Re: Hallman Grove Subdivision
Application #7-06004
North Potomac, MD

DENSITY ANALYSIS
HALLMAN GROVE SUBDIVISION

SK-3

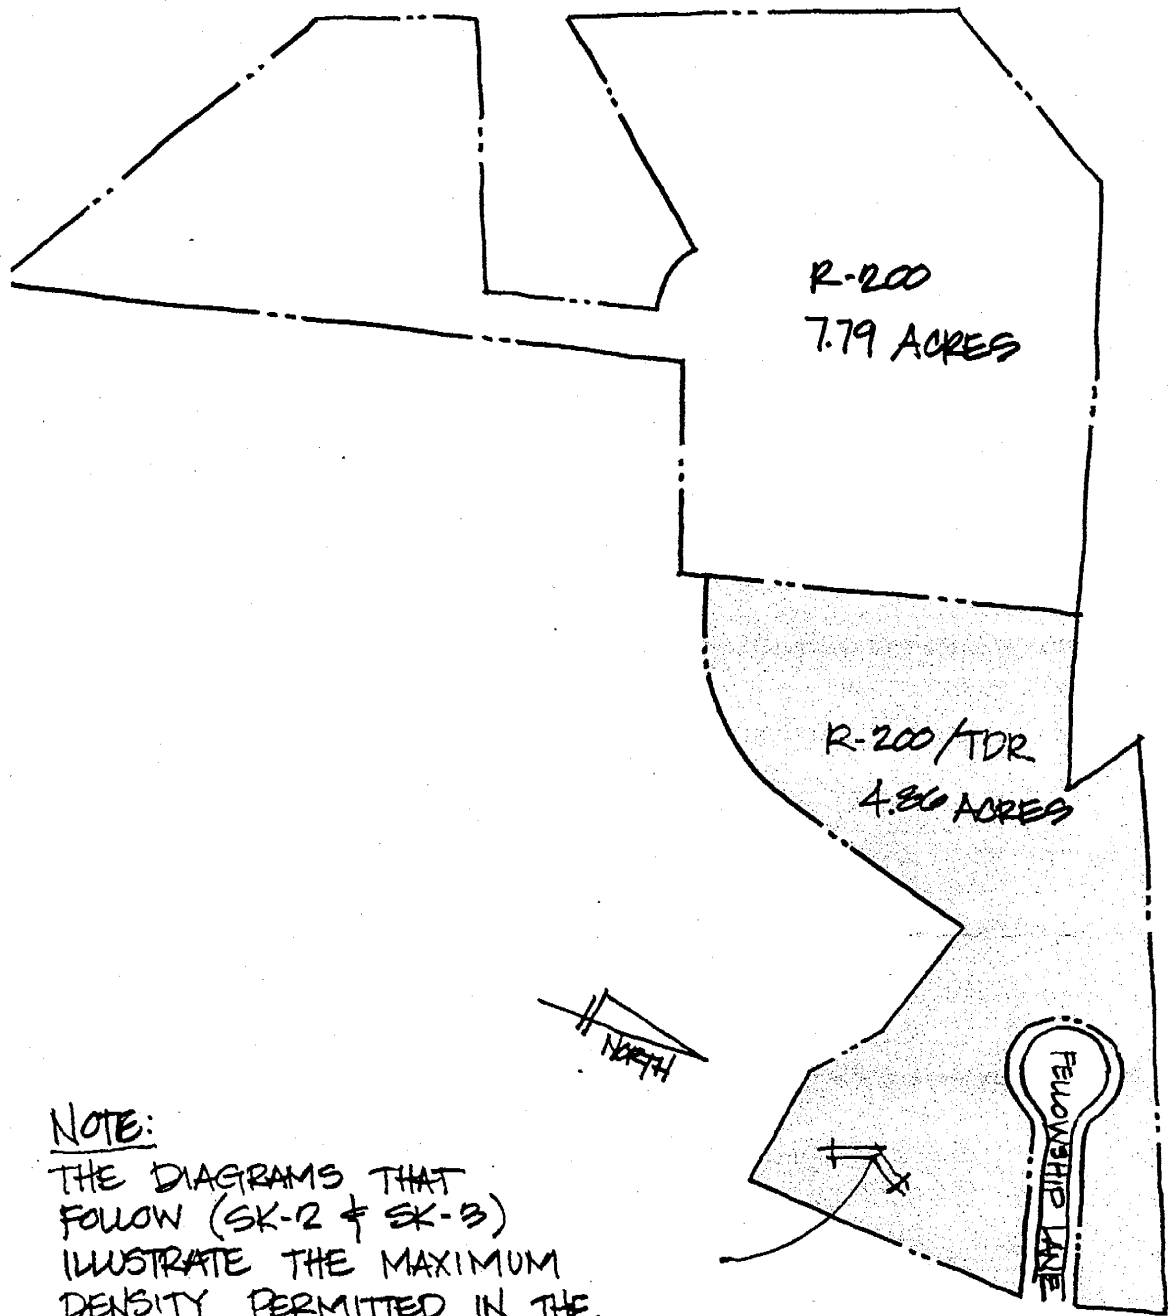
My analysis indicates that no more than 6 dwelling units would be permitted in the separate development of this component tract area. (Refer to SK-3 attached) The zoning ordinance allows these 6 units to be used in the density calculation for the combined tract. The resulting maximum density permitted by the zoning ordinance for the combined tract is 25 dwelling units.

THE DIAGRAMS THAT FOLLOW (SK-2 & SK-3) ILLUSTRATE THE MAXIMUM DENSITY PERMITTED IN THE R-200/TDR-3 COMPONENT AREA OF THE COMBINED TRACT.

1" = 120'
 SK-1
 11 NOV 05

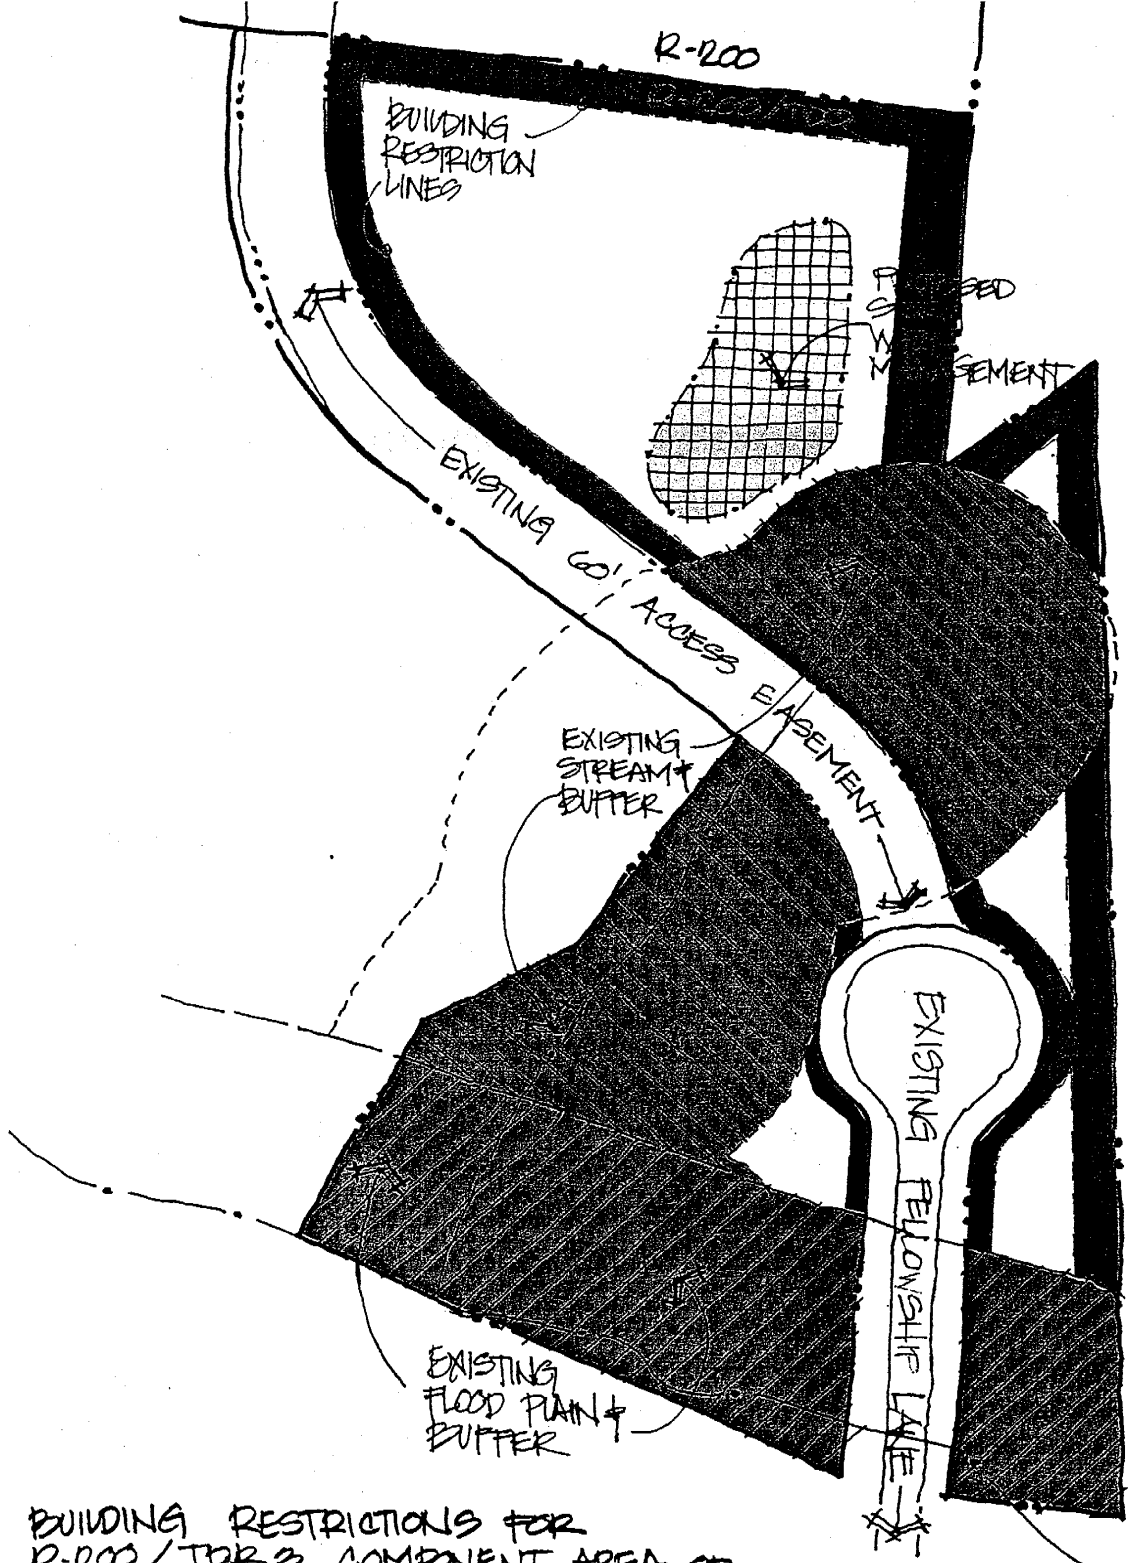
The portion of the parcel located in the R-200 TDR-3 zone is 4.86 acres (Sketch SK-1). Using the tabular density from 59-C-1.62, the developer has proposed a density contribution of 11 dwelling units for this component area of the combined tract. Using the MPDU development criteria of Section 59-C-1.6, 11 dwelling units can not be developed on this component area of the combined tract. Please refer to the attached drawing SK-2 which diagrams the specific development restrictions on this component area. They include significant restrictions imposed by the following:

- The 100 year flood plain and its associated buffers
- The presence of an existing stream and it's associated buffers

- The presence of an existing access easement.
- The requirement for storm water control on this portion of the site.
- The lot size and setback requirements prescribed in 59-C-1.62

SK-12
11 NOV 05

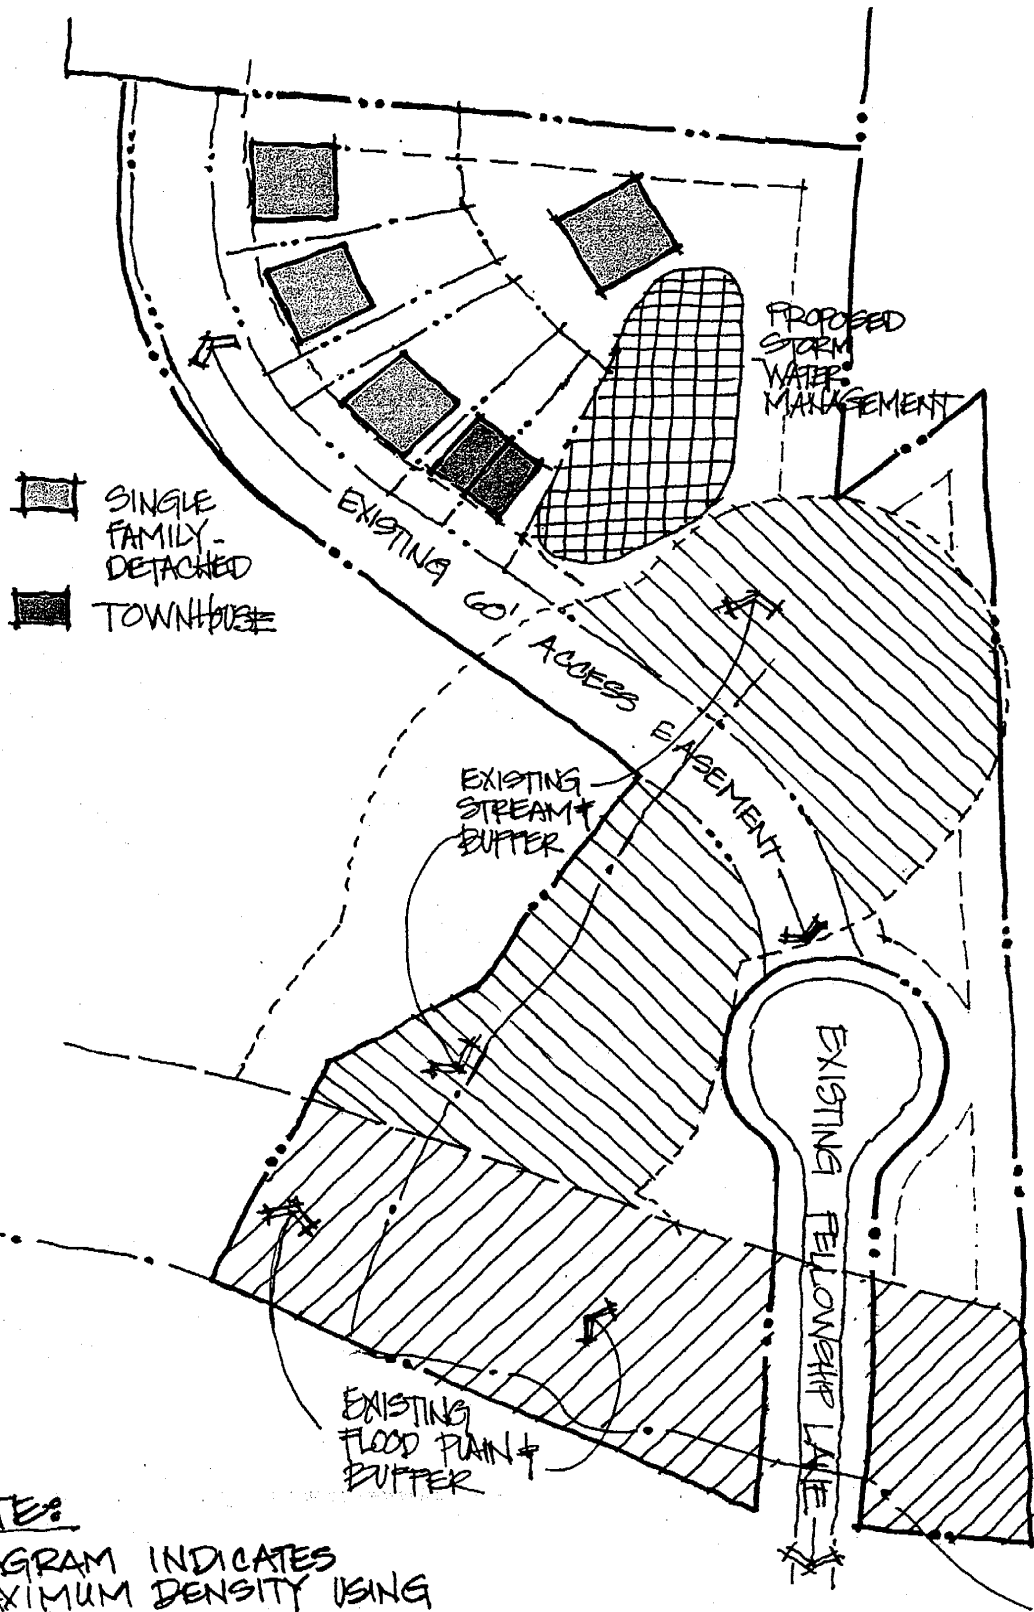
-  FLOOD PLAIN & BUFFER
-  STREAM & BUFFER
-  STORM WATER MANAGEMENT
-  BUILDING RESTRICTION LINES

DIAGRAM INDICATES
 MAXIMUM DENSITY USING
 HOUSING FOOTPRINT SMALLER
 THAN DEVELOPER'S PROPOSED
 HOUSING FOOTPRINT.
